A. This document details the limitations of the cascading option of the AD73360 due to a bug in the current silicon.

Rev.A 6-2000

Figure 2. Cascade Timing for a Three-Device Cascade

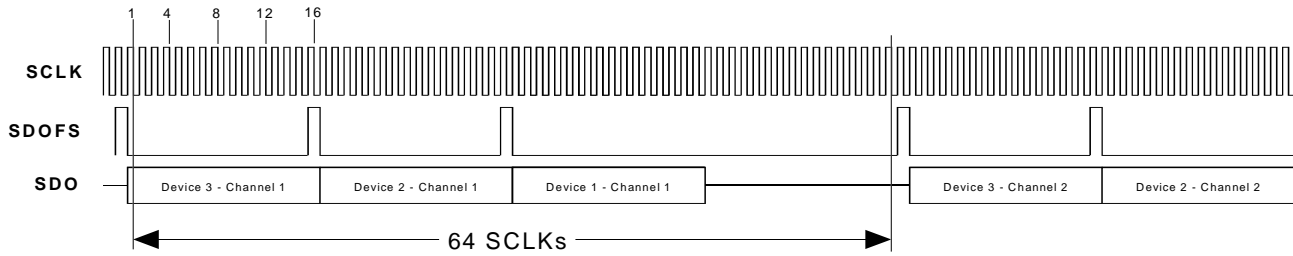
For cascades of more than two devices the AD73360 will leave too many SCLKs between transmitting channel information. This increases the time it takes to transmit the ADC data and since a DSP or microcontroller must read data from all the ADCs in the cascade in one sample period the number of devices which can be cascaded will be limited. Figure 2 shows the effect the additional SCLKs have on a cascade of three devices.

For a cascade of a given length, the SCLK rate and Sample Period will determine if the cascade can be used successfully. A low sample rate will allow more time for the ADC data to be read. Similarly a high SCLK rate will transmit the data in a shorter time. Since both the SCLK rate and Sample Rate are derived from the same DMCLK the number of combinations is limited. As most applications will require a predetermined sample rate, the SCLK speed will be the limiting factor in the cascade length that can be used. Table I shows the maximum cascade length for a given SCLK and Sample Rate. The table assumes that a MCLK of 16.384MHz is used.
